PRAIRIE ISLAND NUCLEAR GENERATING PLANT

License Amendment Request dated March 25, 2003 Safety Analyses Transition

Description of Proposed Changes, Reasons for Requesting the Changes, Supporting Safety Evaluation and proposed Determination of No Significant Hazards Consideration

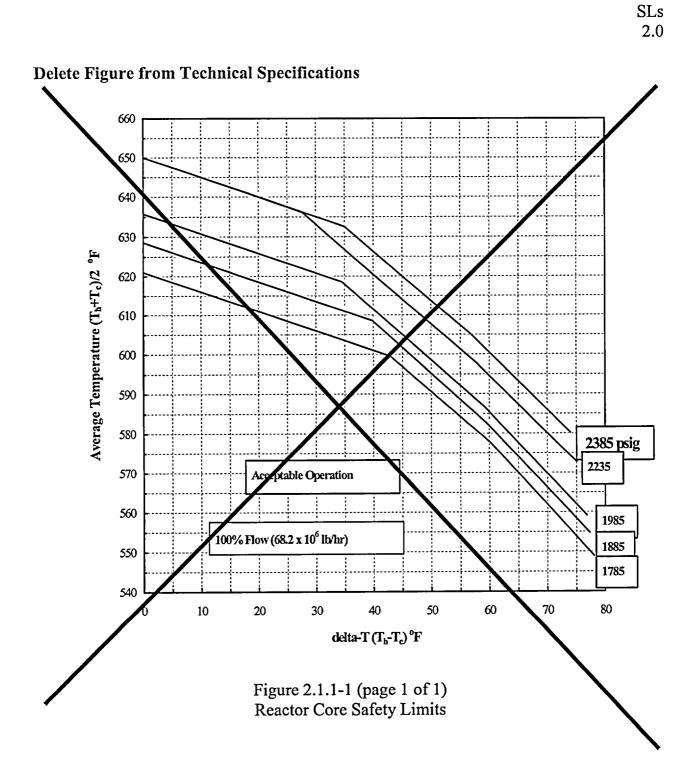
Currently, TS 2.1.1, "Reactor Core SLs," refers to Figure 2.1.1-1, "Reactor Core Safety Limits." Based on the use of the NRC approved methods documented in Reference 2, this figure is being relocated to the COLR. The appropriate additional requirements

In MODES 1 and 2, the combination of THERMAL POWER, Reactor Coolant System (RCS) highest loop average temperature, and pressurizer pressure shall not exceed the **limits** <u>SLs</u>-specified in <u>the COLR</u> Figure 2.1. 1-1 and the following SLs shall not be exceeded:
